William Kennedy, P.E., *Comments Regarding the Proposed NPDES
Permit for Public Service of New Hampshire's Merrimack Station*
(August 2014)

Comments Regarding the Proposed NPDES Permit
for
Public Service of New Hampshire's
Merrimack Station

William Kennedy, P.E.

August 2014

Schema Impianto Evaporazione-Cristallizzazione di La Spezia

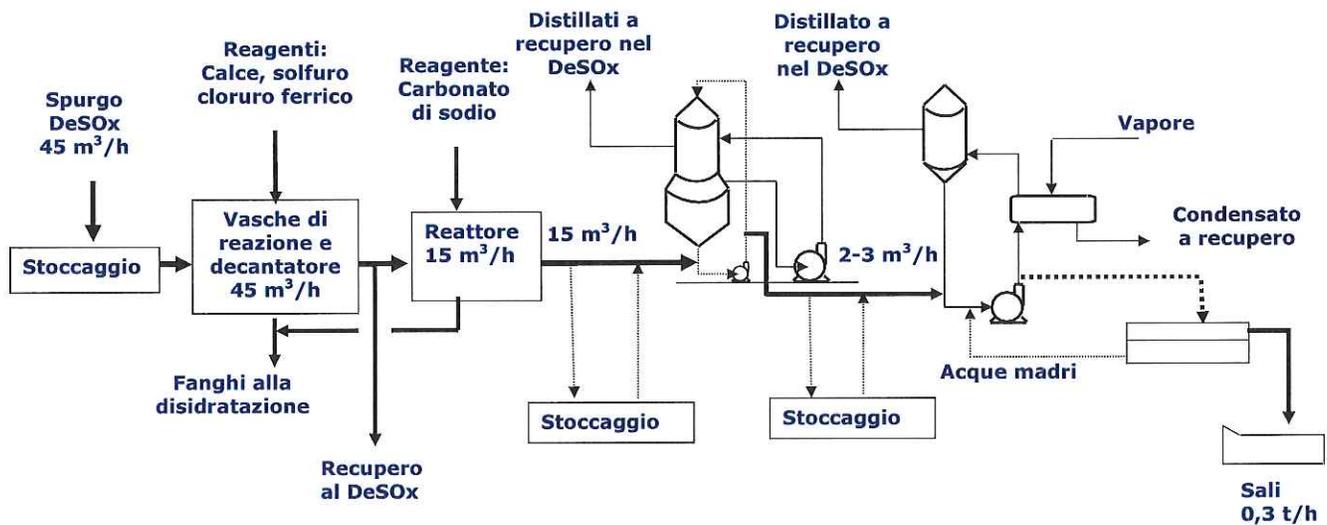
The estimated annual flow rate of the FGD discharge is of 200.000 m³/y (not clear whether calculated at maximum capacity); while the treatment capacity of the ITSD/SEC plant is of 15 m³/h (i.e. 131,400 m³/h). The ITSD/SEC plant appears to be undersized with respect to the actual FGD discharge flow rate.

- Considering wastewater flow diagram provided by the site for the permit application and included in the EMAS statement 2012, it is clear that the FGD discharge can go either to the ITSD/SEC plant (chemically treated, evaporated, condensed and then reused) or to ITAR (chemically treated and then reused or discharged to sea). A "normally closed" valve is indicated in the flow diagram on the connection between FGD and ITAR (see Appendix B).

CENTRALE TERMOELETTRICA DI BRINDISI SUD SCHEMA DI TRATTAMENTO ACQUE REFLUE

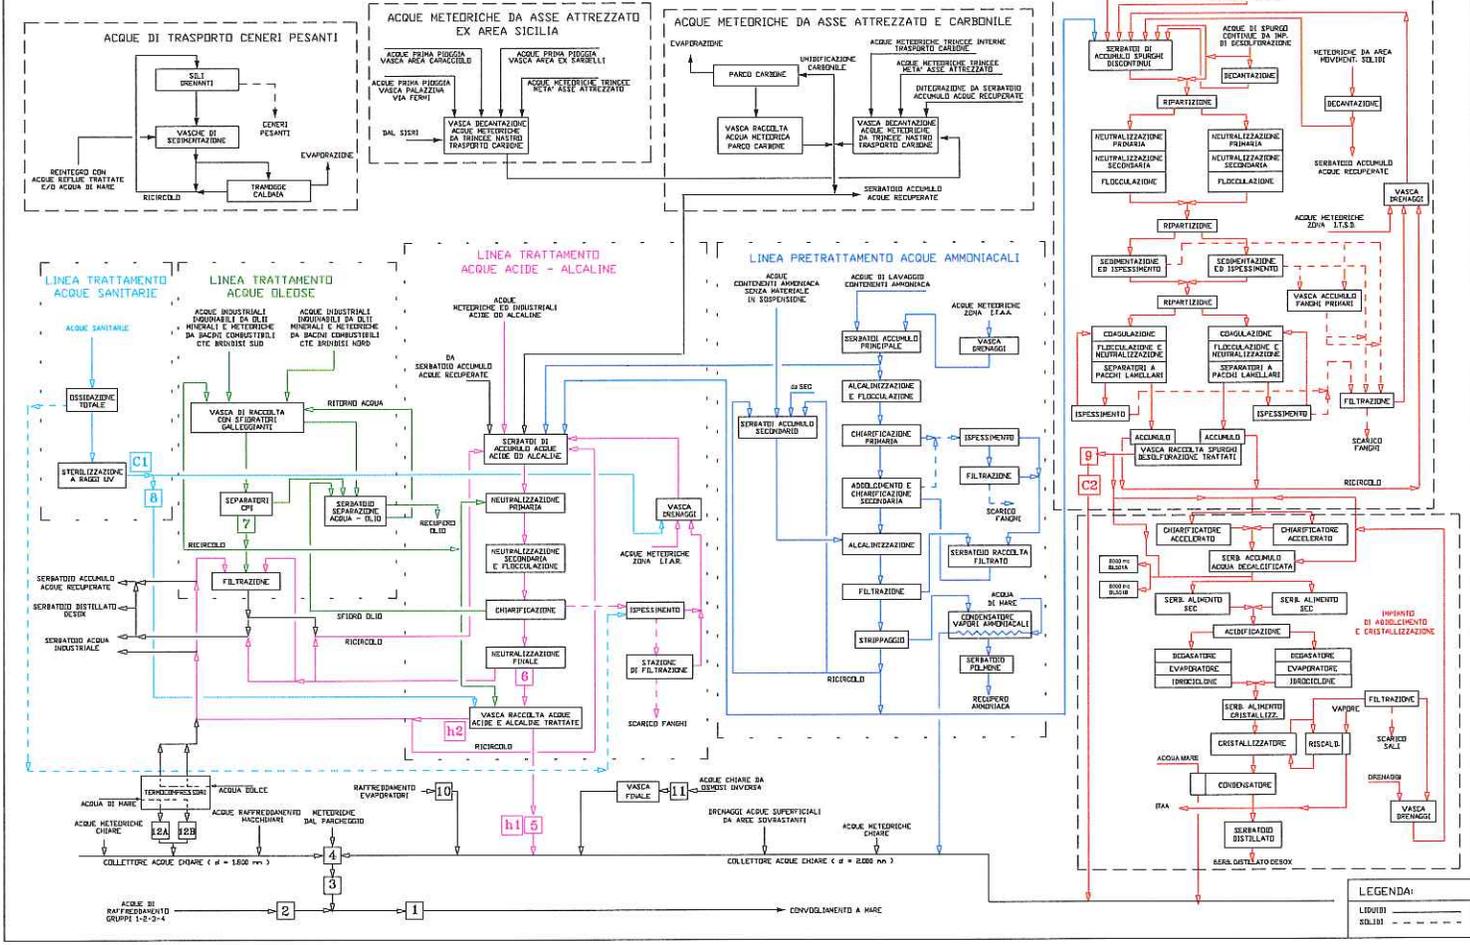
- In a process flow diagram of the site wastewater treatment system (attached to the permit application), a stream named "C2" goes directly from ITDS plant to the sea, likely the S9S discharge point (see Appendix C).
